# **PLANNING COMMITTEE**

## **Amendment Sheet.**

### **P/02411/022 – Thames Central, Hatfield Road, Slough, SL1 1QE**

### First Floor (Level 2)

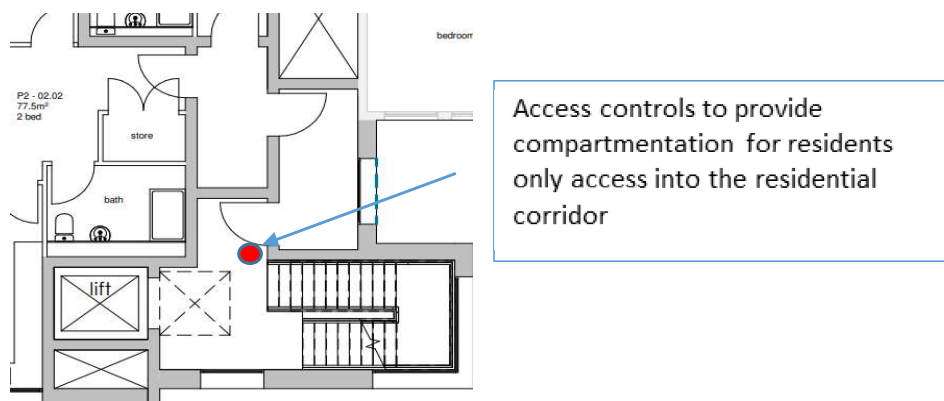
This appears to include the cycle storage for all occupants. Formal surveillance should be present in this location.

This floor introduces access to two other cores. Merged cores should generally be avoided as they benefit those intent on crime and anti-social behaviour providing circular free movement within a development and several routes to and from an offence. Therefore, this floor represents a significant risk in terms of crime and anti-social behaviour, again this could be mitigated with robust access controls and formal surveillance.

Secured by Design highlights the importance of compartmentation in large developments and provides some guidance. The applicant must not make the mistake of considering all offenders being external to a development. Neighbourhood disputes impact heavily police resources. Occupants should only have access to areas within the development that they have a legitimate need to access, e.g. a resident located on the 9<sup>th</sup> floor should have access through the communal doors, to mail services, to the parking and cycle storage areas, to the appropriate stair and lift core to access their floor and the floor plate of the level 9. They should not have access to other stair cores or floor plates and should be treated like a visitor should they wish to gain entry at these points.

The applicant therefore needs to address compartmentation of the development through their access controls, how visitor entry will be facilitated and where these entry systems will be located.

1. It is proposed to use a programmable key fob access control system throughout the building.
2. Secure key fob access will be provided at first floor level to the circulation cores.
3. Access at each floor level (2<sup>nd</sup> floor upwards) will be limited to the residents of each floor by way of a secure access lobby.

4. A management suite has now been located at first floor level allowing visual monitoring of the both the vehicular access and the pedestrian access. Whilst there is no view to the west this could if necessary be provided by way of an additional window as noted on the attached mark-up.
